As per the Protection Update state machine row 13,

Figure :1

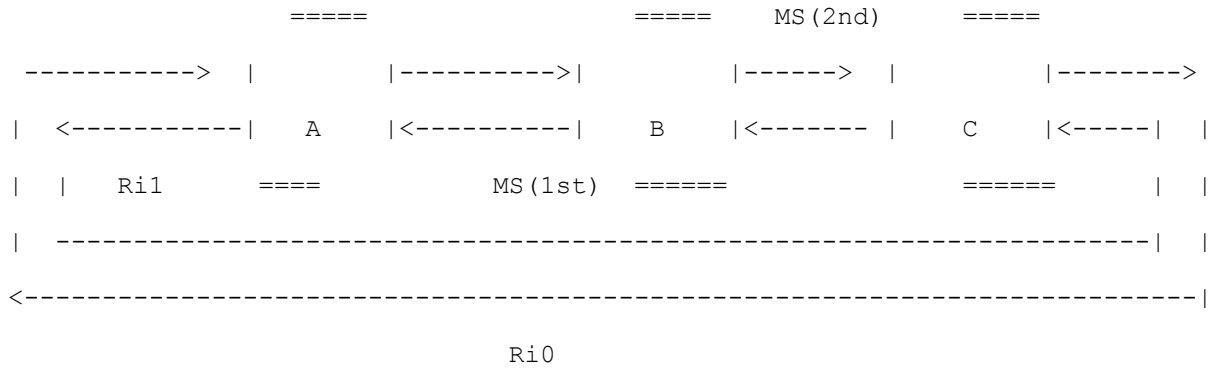
Considering the scenario above , the first manual switch on the ringlet 1 of node A will cause EDGE on the East side of A. Now if a second MS is applied on the ringlet 0 of the node C ,the protection update state machine on the node C shall detect that as above row condition is met and the MS will be dropped (spanProtAdmin = IDLE).However the node A would not be aware of the MS which was applied on node C (TP frames from node C will contain IDLE) and continue to be active.

In such case the MS- MS condition would lead to single EDGE which is caused by the first request.
